Preliminary Drainage Report
for
Rolling Hills Ranch PUD
at
Meridian Ranch

EL PASO COUNTY, COLORADO

September 2019

PCD Project No. PUDSP-19-XXX

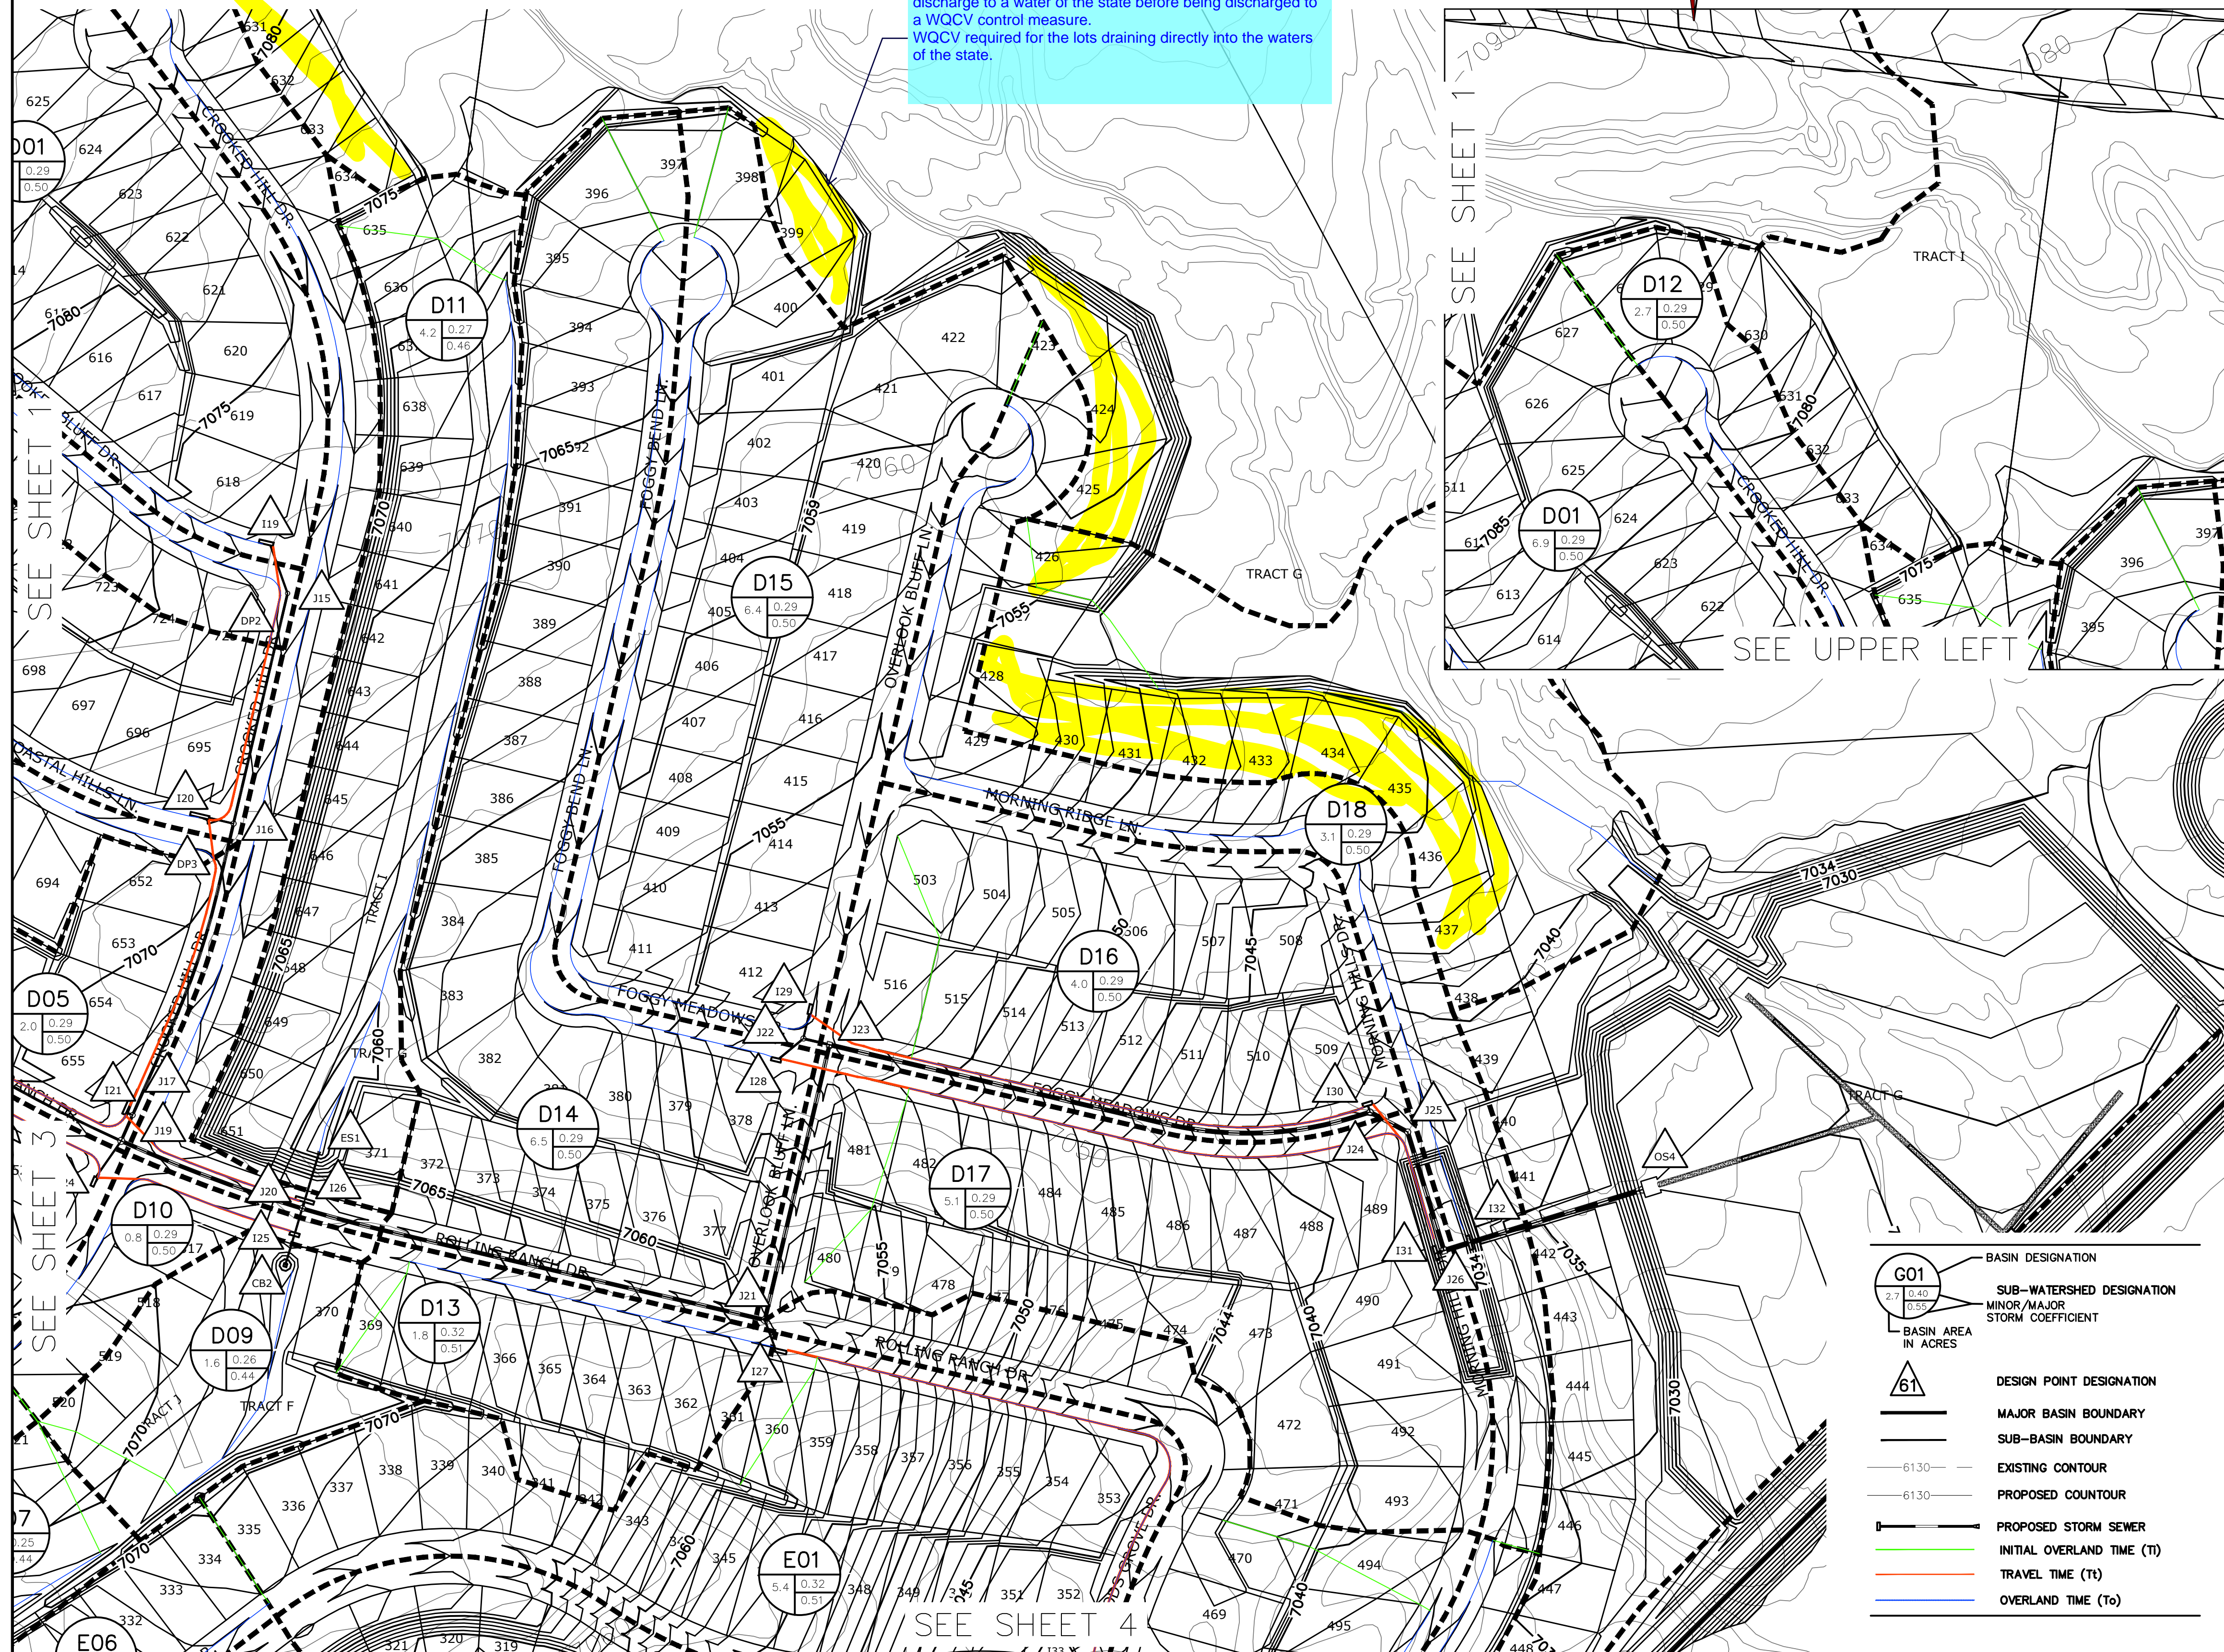
Per ECM I.7.1.C.4. Stormwater from the site must not discharge to a water of the state before being discharged to a WQCV control measure.
 WQCV required for the lots draining directly into the waters of the state.

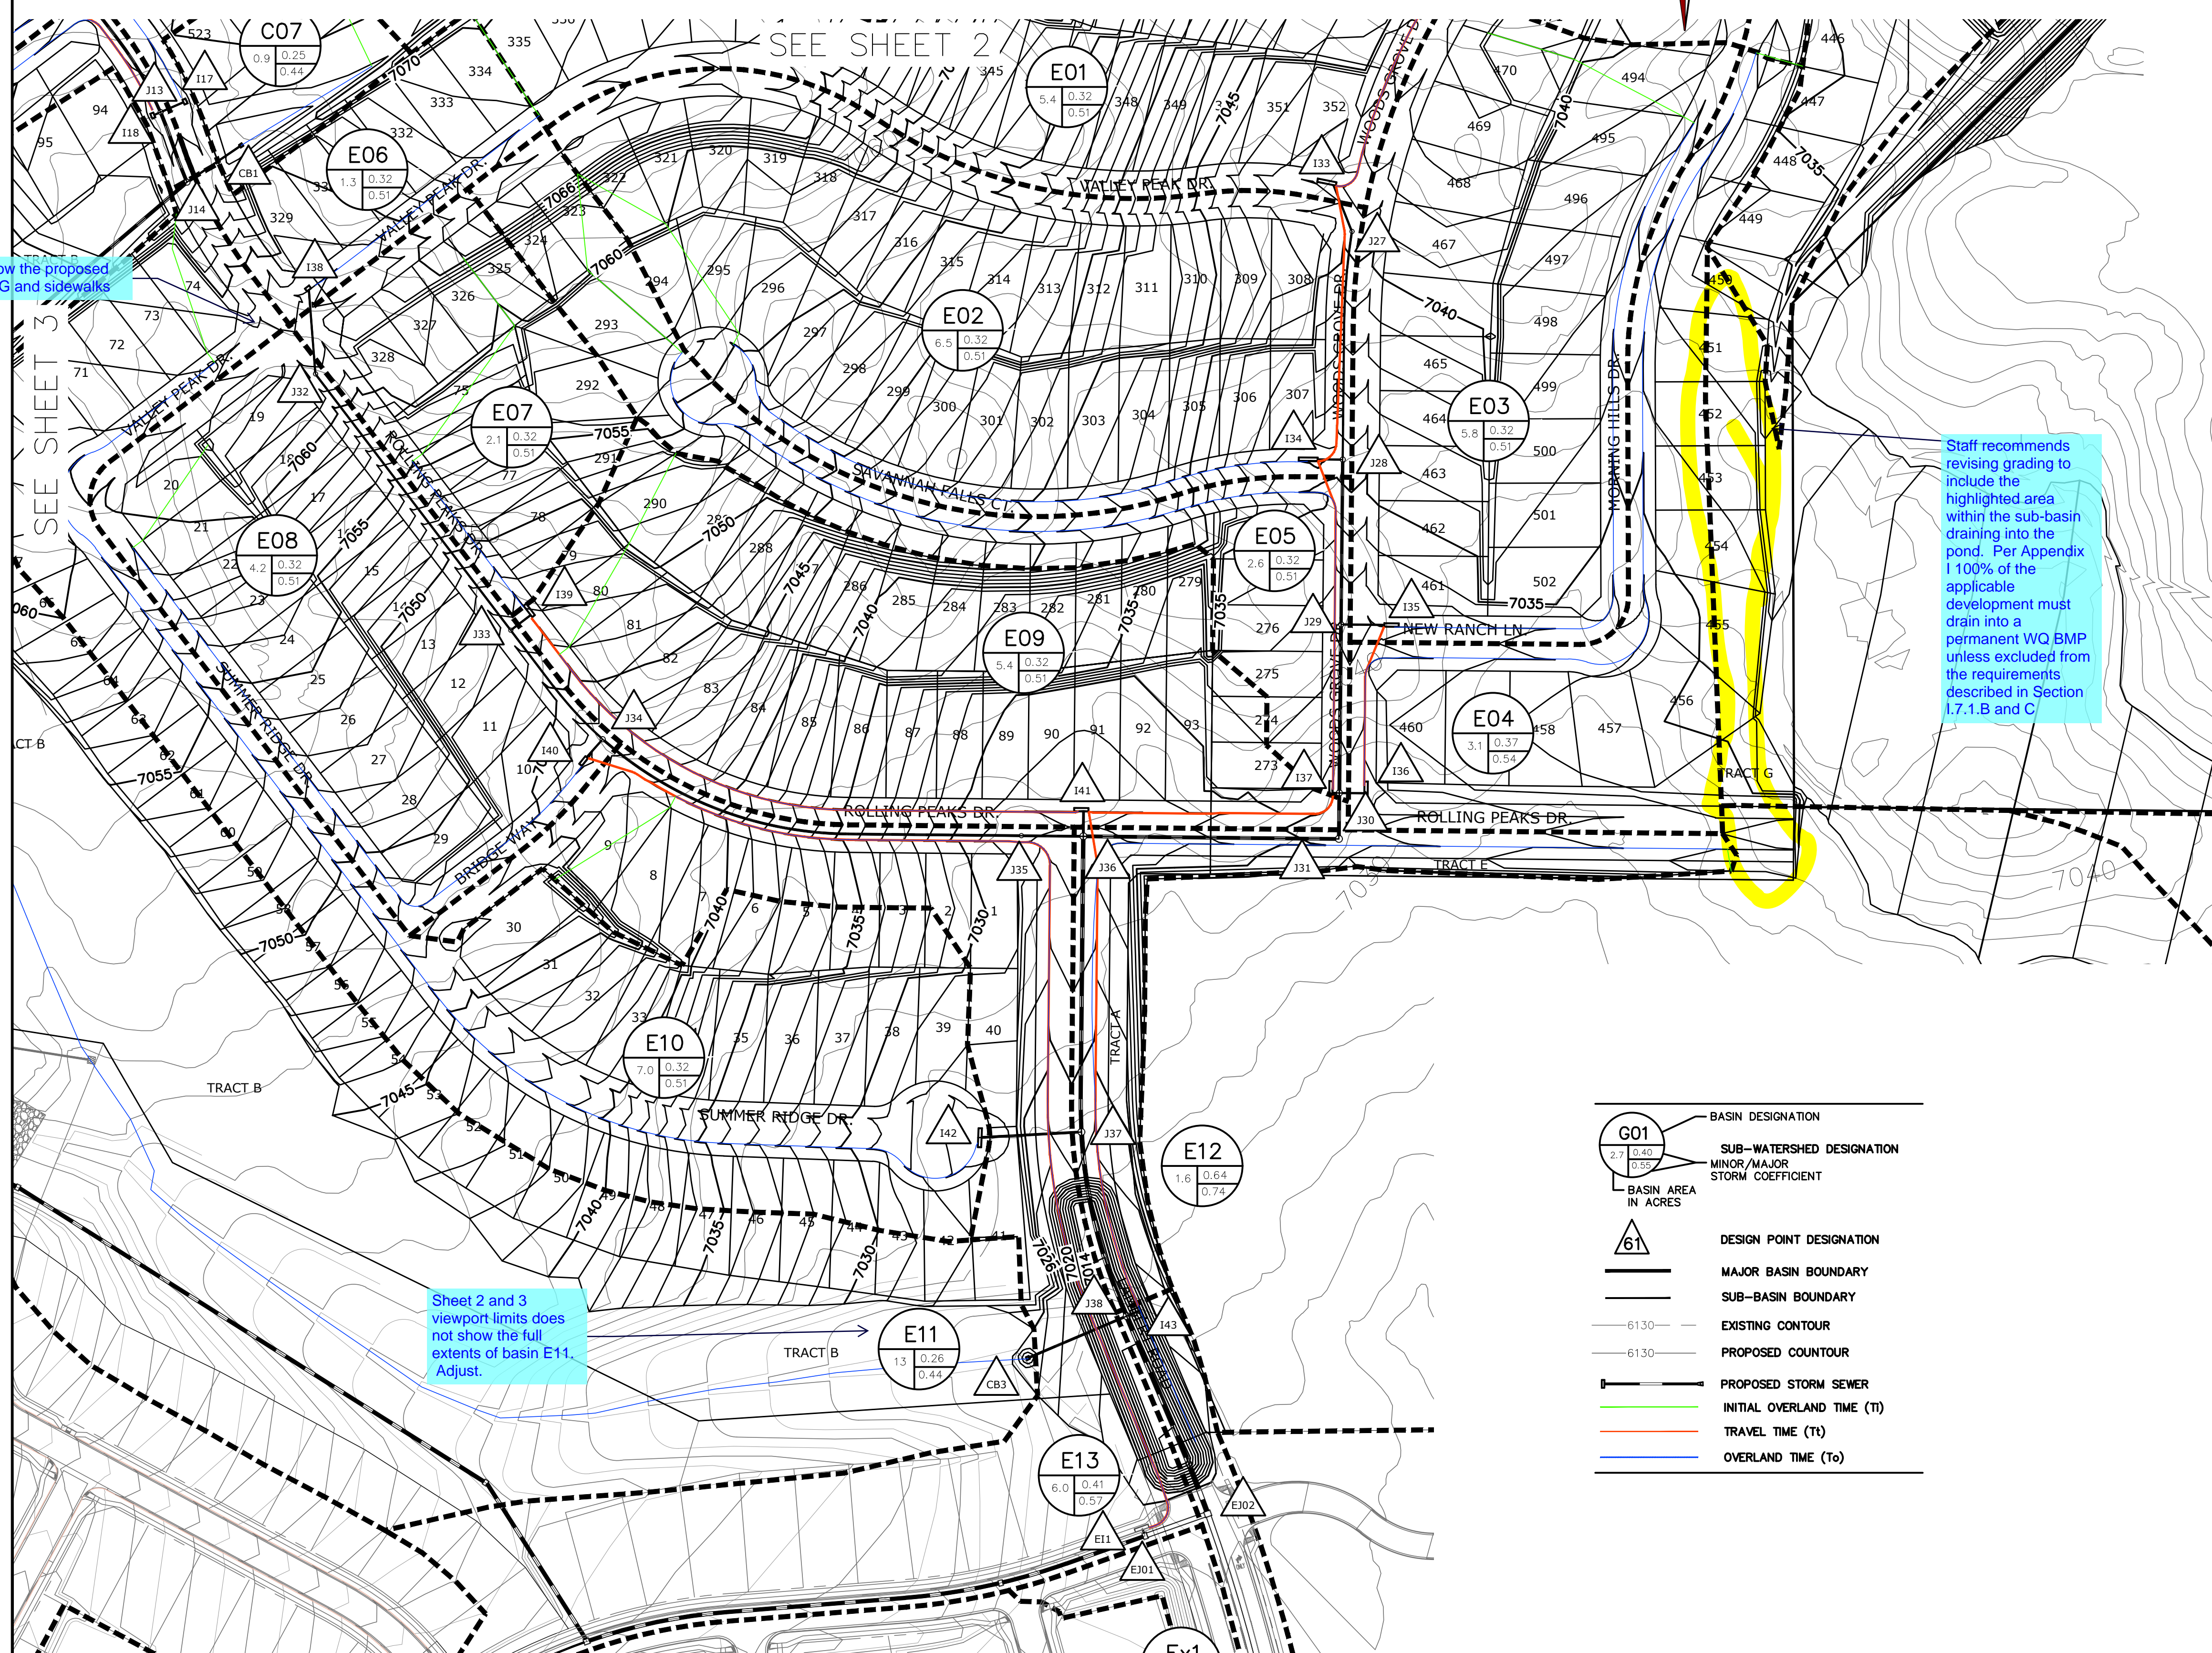
Staff recommends revising grading to include the highlighted area within the sub-basin draining into the pond. Per Appendix I 100% of the applicable development must drain into a permanent WQ BMP unless excluded from the requirements described in Section I.7.1.B and C

Sheet 2 and 3 viewport limits does not show the full extents of basin E11. Adjust.

update page numbers for the rational drainage map
